ECE/TRANS/WP.29/GRSG/2008/15
11 April 2008

Regulation No. 43
(Safety glazing)

Proposal for Supplement 11 to Regulation No. 43

Transmitted by the expert from Spain ^{*/}

Laminated glass panes other than windscreens having a regular light transmittance > 70 per cent

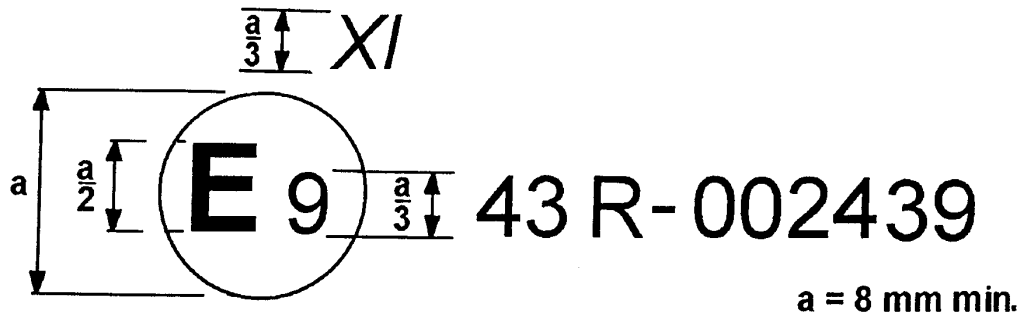
Annex 2, add the following approval mark example:

The above approval mark affixed to a laminated glass pane other than a windscreen, shows that the component concerned has been approved in Spain (E 9) pursuant to Regulation No. 43 under approval No. 002439. The approval number indicates that the approval was granted in accordance with the requirements of Regulation No. 43.
